PUBLIC INTEREST REVIEW FOR GROUNDWATER APPLICATIONS

TO: Water Rights Section Date September 6, 2016
 FROM: Groundwater Section Aurora C Bouchier
Reviewer's Name
 SUBJECT: Application G- 18308 Supersedes review of na
Date of Review(s)

A. GENERAL INFORMATION: Applicant's Name: Arkley County: Polk

Water-Level Trends in Nearby Wells

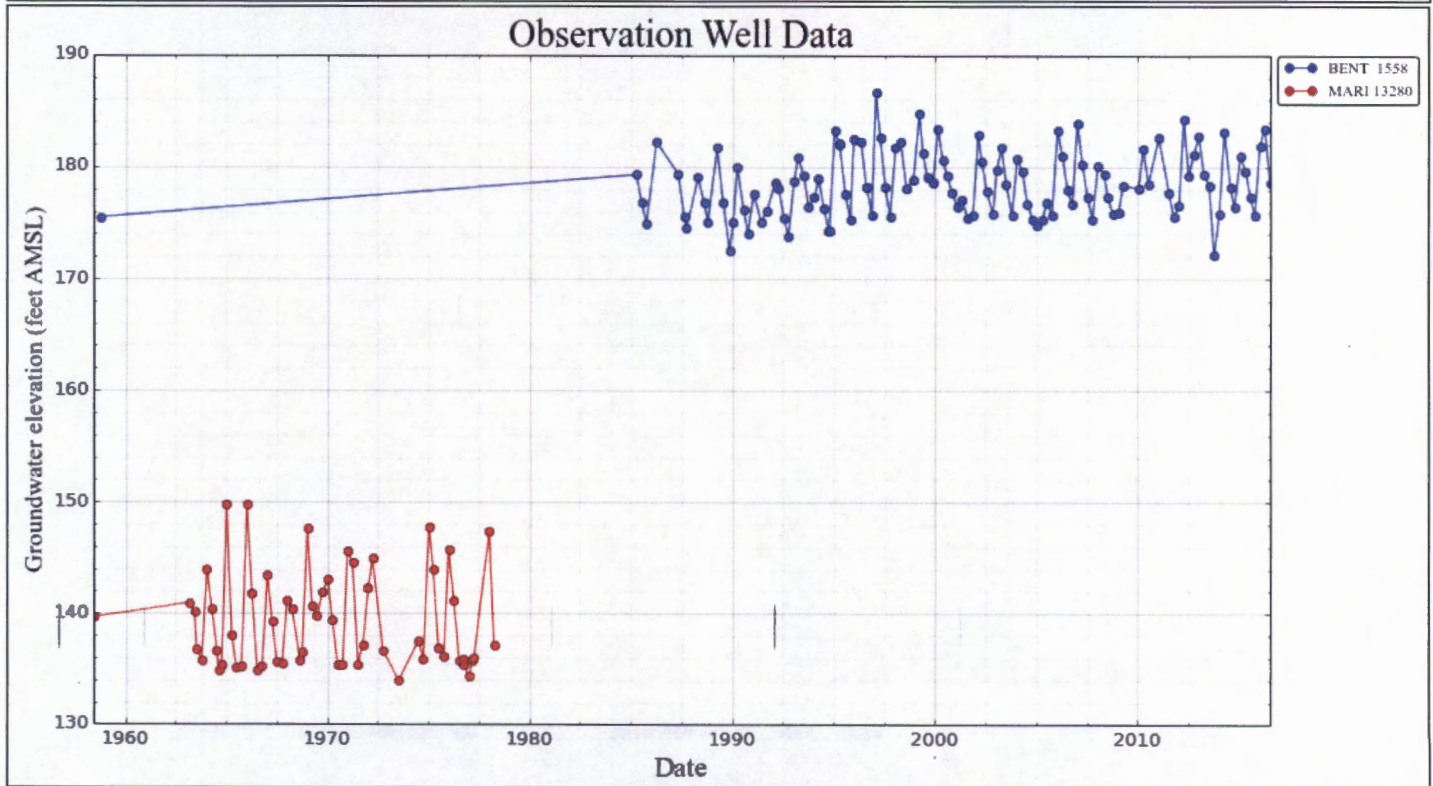
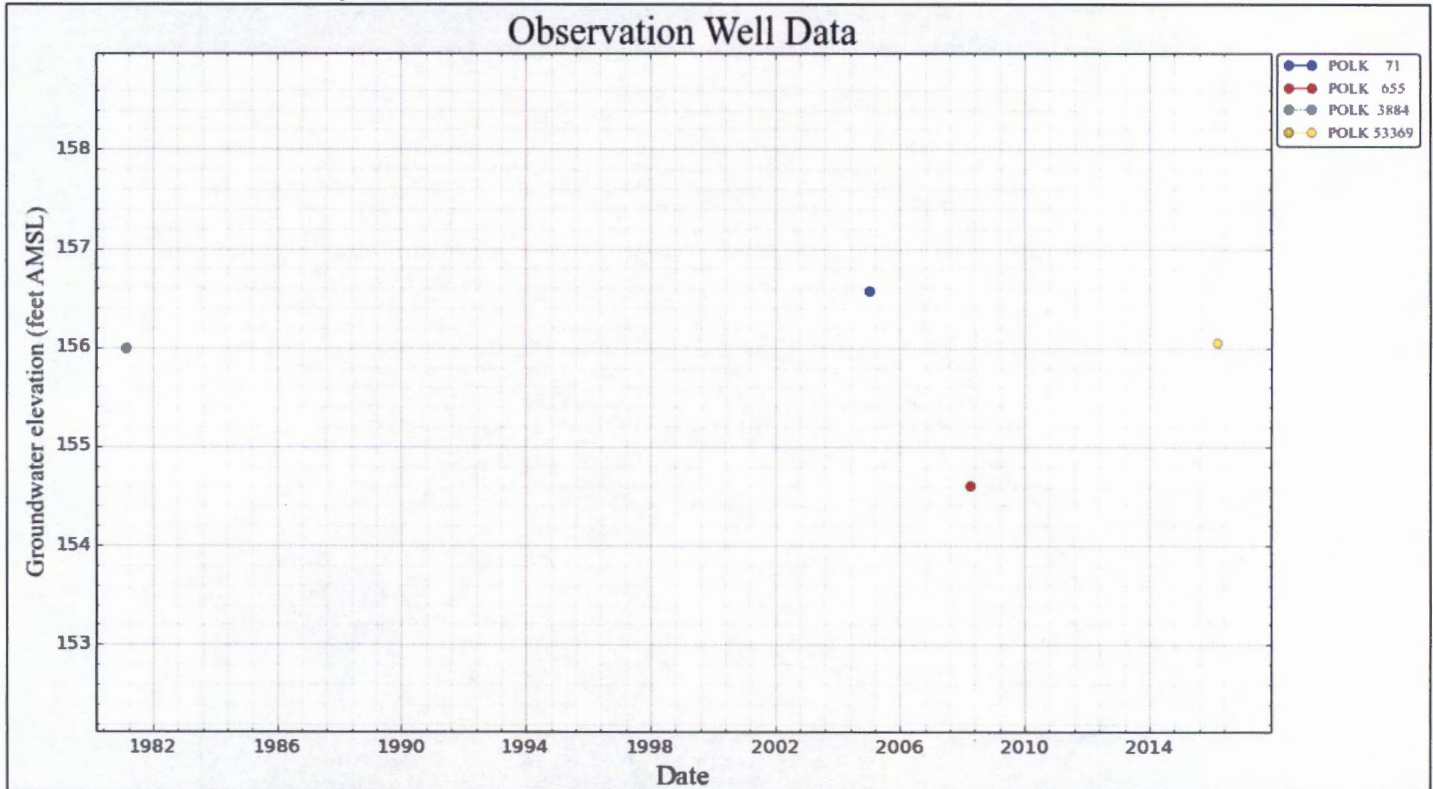
The nearest wells with long term water level reporting, similarly located within the unconsolidated Holocene floodplain, are MARI 13280 (located 3.75 miles to the north) and BENT 1558 (located 8.9 miles to the south). The hydrograph for MARI 13280 and BENT 1558 shows no long term decline.

Well Statistics for Nearby Wells

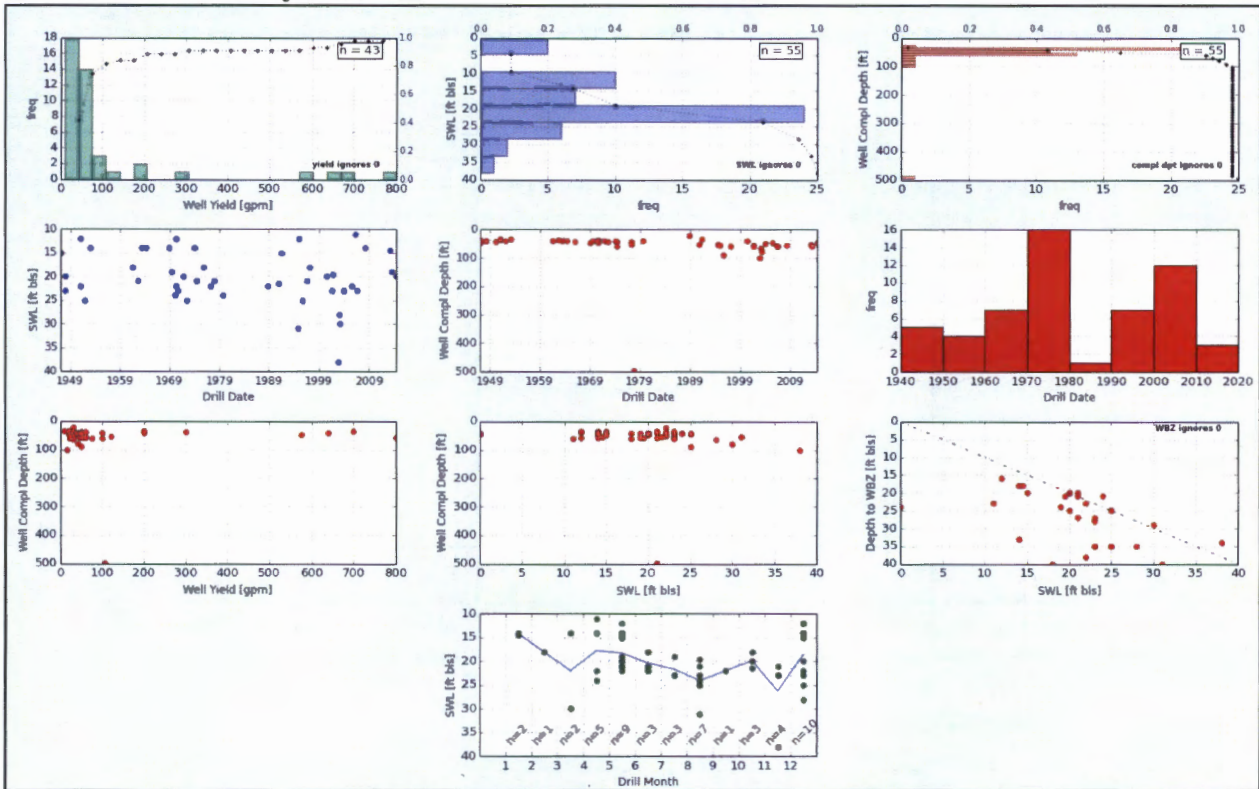
Comments: The OWRD database shows 22 out of 29 wells in the section with static water levels above the zone at which water was first encountered, indicating confined conditions (see Well Statistics below). The proposed location is on a SLIGHT high within the meander belt zone and, like most other wells in the Section, will likely have a water level above the zone at which it is encountered. Therefore the pertinent rules (OAR 690-502-0240) do not apply.

Basis for aquifer confinement evaluation: 22 out of 29 well logs in the OWRD database show static water levels rising above the zone at which water was first encountered, indicating confined conditions.

Transient Stream Depletion

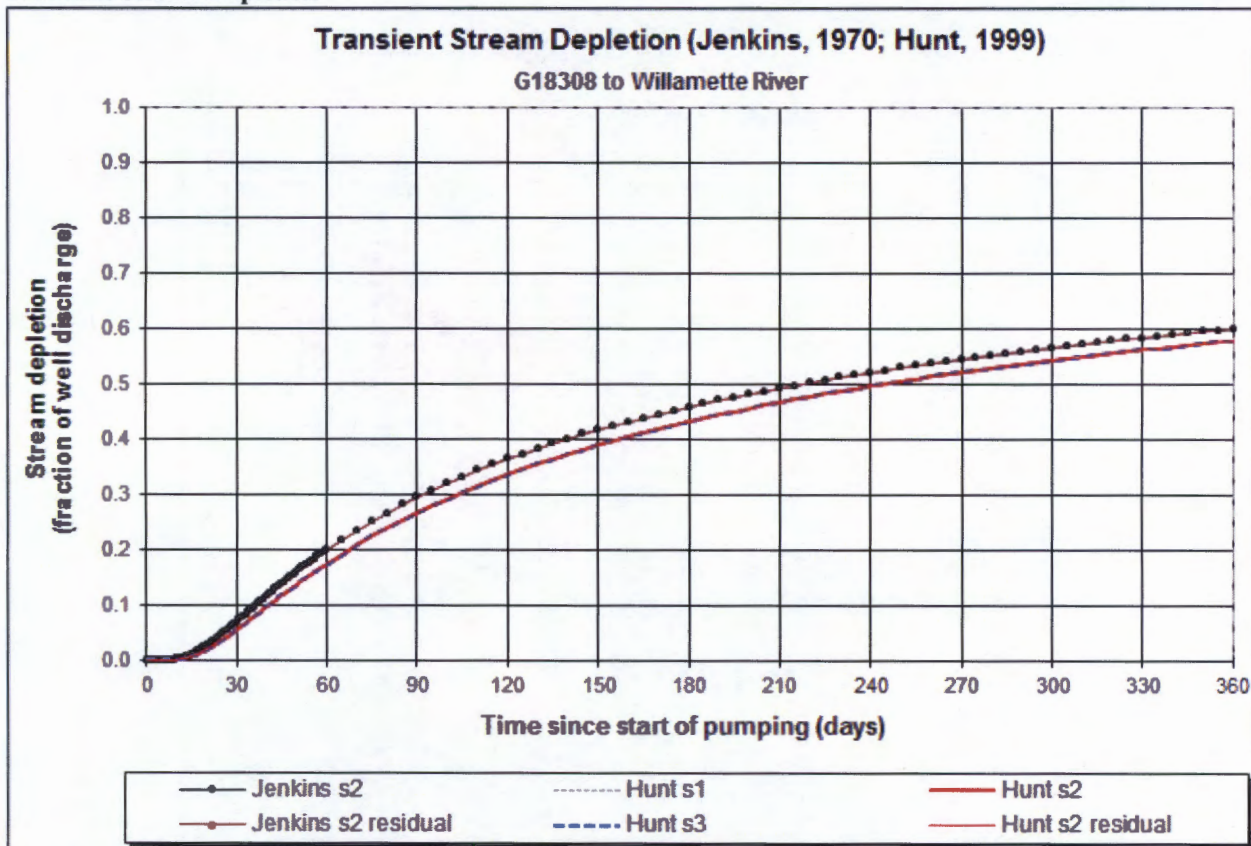
Comments: Stream interference was estimated using the Hunt model (1999, see attached plot). A transmissivity value of 20,000 ft²/day was used based on a single well pump tests for other wells which are similarly located in the meander belt/floodplain of the Willamette River. Because the aquifer is somewhat confined in the area between the well and the stream, pumping impacts will propagate to the stream quickly.
